PRIORITY DEVELOPMENT PROJECT (PDP) STORM WATER QUALITY MANAGEMENT PLAN (SWQMP)

FOR
SUMMIT AVENUE
TM-2023-0003
10939 Summit Avenue
Santee, CA 92071

This PDPSWQMP presents a revision to the December 19, 2024 report pursuant to the City of Santee plan check comments received January 20, 2025. The following text identifies the plan check comments along with the responses in bold.

DRAINAGE MANAGEMENT EXHIBIT FOR SUMMIT AVENUE

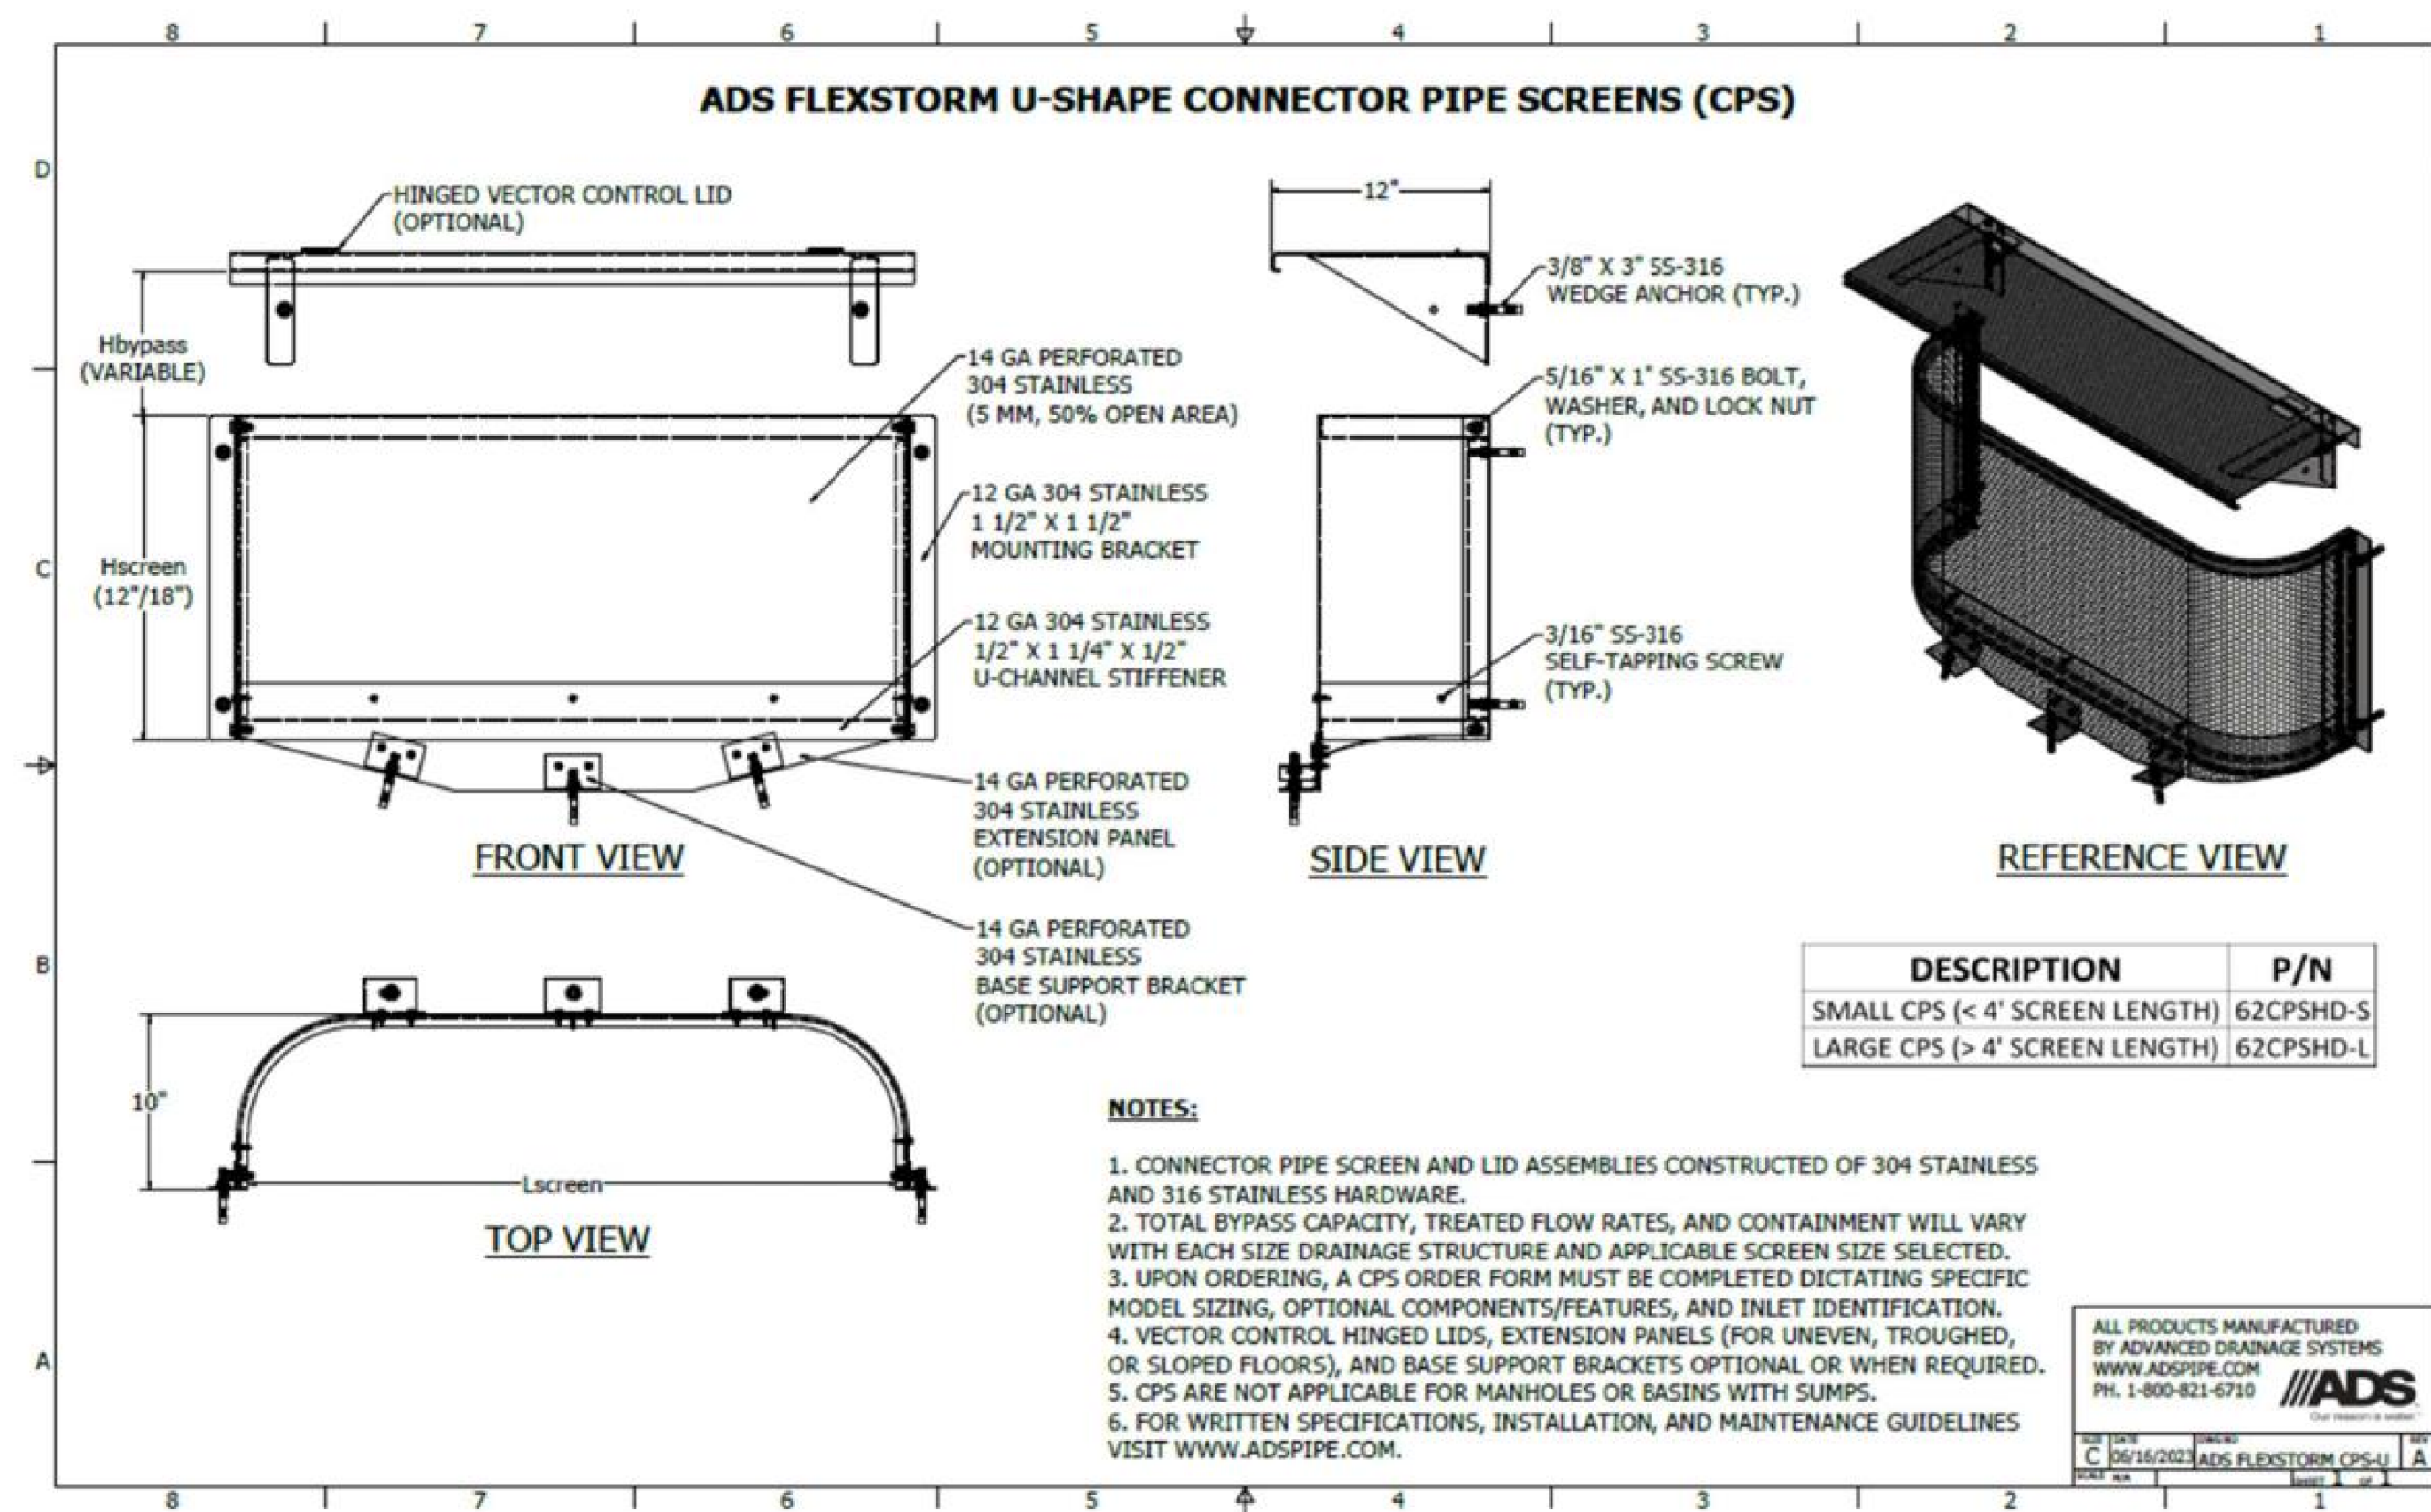
2j i. Storm Water Quality Management Plan: Page 48 (DMA Exhibit): Update exhibit to include a DMA for the northern portion of the parcel. Suggest identifying it as self-mitigating.

2j iv. Storm Water Quality Management Plan: Page 48 (DMA Exhibit): Color-coordinate/update exhibit to differentiate between pervious and impervious features.

2j vi. Storm Water Quality Management Plan: Page 48 (DMA Exhibit): Call out/identify locations of all full trash capture devices. Currently, the exhibit only calls out one.

2j ix. Storm Water Quality Management Plan: Page 48 (DMA Exhibit): Call out/identify locations of pet waste stations. Include details of the pet waste stations to the sheet including make, model, example signage, etc.

2j x. Storm Water Quality Management Plan: Page 48 (DMA Exhibit): Add details of each BMP (vault, MWS, tree well, full trash capture device) to the sheet.

2j xii. Storm Water Quality Management Plan: Page 48 (DMA Exhibit): Add a note about the non-vegetated channel to the “Notes” section on the exhibit.

2j xiii. Storm Water Quality Management Plan: Page 48 (DMA Exhibit): Add a brow ditch icon to the legend.

2jxiv. Storm Water Quality Management Plan: Page 48 (DMA Exhibit): Add a note about the HOA being responsible for maintenance of the pet waste stations.

Exhibit updated to add a Self-mitigating DMA to northern area within parcel.

Impervious hatch added to exhibit to identify impervious area. Pervious areas remain unhatched.

Only one trash capture device is proposed – at the most downstream curb inlet prior to entering the Storm Trap Vault. Pipe screen or equivalent callout added.

Pet Waste Station symbol and callout added to DMA exhibit. Locations were determined per the BMLA Conceptual Landscape Plan, dated 1/29/2024. Pet Waste Station details (make, model, example signage, etc.) to be provided in Final Engineering.

Preliminary MWS Detail and Tree Well Detail added to DMA Exhibit. Vault Detail and Trash Capture Device Detail to be provided in future submittal.

Discussion of non-vegetated channel added to DMA Exhibit Notes.

Brow ditch icon added to legend.

Note 10 added to DMA Exhibit - "HOA to be Responsible for Maintenance of the Pet Waste Stations".

HYDROMODIFICATION MANAGEMENT EXHIBIT FOR SUMMIT AVENUE (POST-PROJECT)

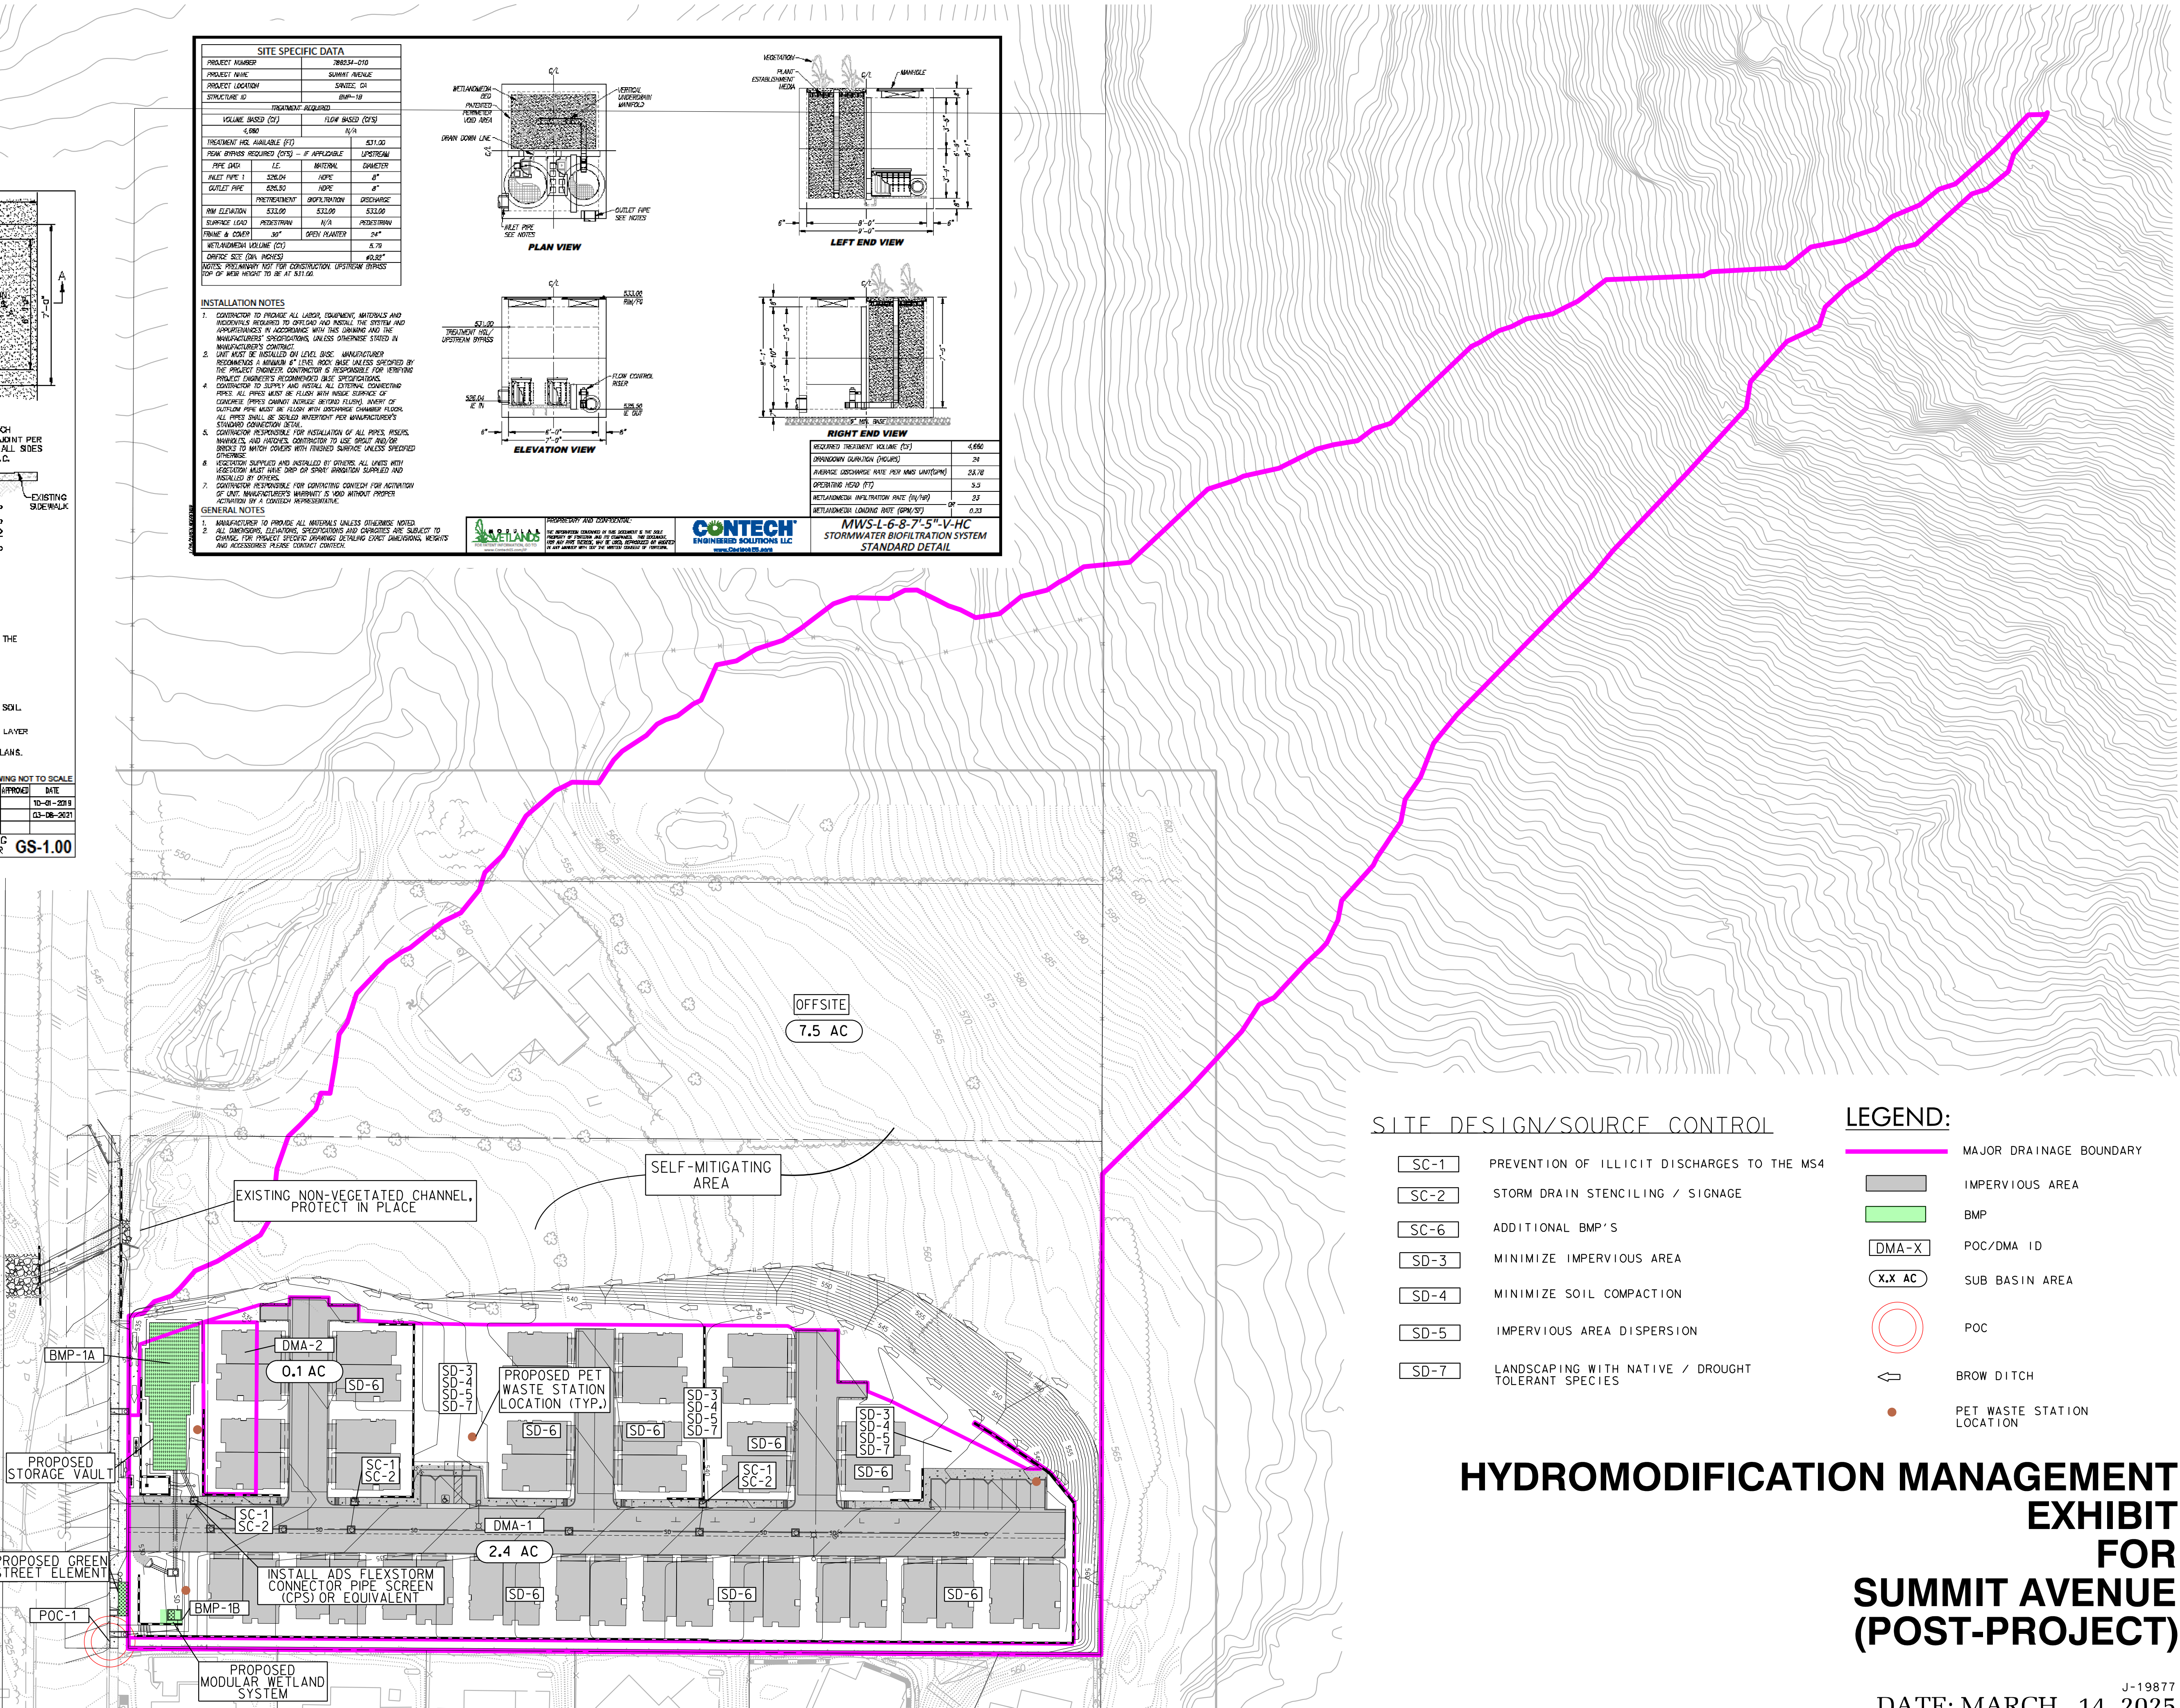
11. SWQMP Page 100, the exhibit does not show full frontage improvements to the northern property line. Revise the exhibit to show this correctly.

2o. i. Page 79 (Hydromodification Exhibit): Update exhibit to include a DMA for the northern portion of the parcel. Suggest identifying it as self-mitigating.

2o. iii. Page 79 (Hydromodification Exhibit): Color-coordinate/update exhibit to differentiate between pervious and impervious features.

2o. v. Page 79 (Hydromodification Exhibit): Call out/identify locations of all full trash capture devices. Currently, the exhibit only calls out one.

2o. viii. Page 79 (Hydromodification Exhibit): Call out/identify locations of pet waste stations. Include details of the pet waste stations to the sheet including make, model, example signage, etc.

2o. ix. Page 79 (Hydromodification Exhibit): Add details of each BMP (vault, MWS, tree well, full trash capture device) to the sheet.

2o. xi. Page 79 (Hydromodification Exhibit): Add a note about the non-vegetated channel to the “Notes” section on the exhibit.

2o. xii. Page 79 (Hydromodification Exhibit): xii. Add a brow ditch icon to the legend.

Noted; Post-project Hydromodification Management Exhibit has been updated to show full frontage improvements.

Self-Mitigating Area callout added.

Impervious area hatch was already shown and called out on hydromodification exhibit and legend. Please refer to exhibit.

Only one trash capture device is proposed – at the most downstream curb inlet prior to entering the Storm Trap Vault. Pipe screen or equivalent callout added.

Pet Waste Station symbol and callout added to Hydromodification Exhibit. Locations were determined per the BMLA Conceptual Landscape Plan, dated 1/29/2024. Pet Waste Station details (make, model, example signage, etc.) to be provided in Final Engineering.

Preliminary MWS Detail and Tree Well Detail added to Hydromodification Exhibit. Vault Detail and Trash Capture Device Detail to be provided in future submittal.

Discussion of non-vegetated channel added to Hydromodification Exhibit Notes.

Brow ditch icon added to legend.
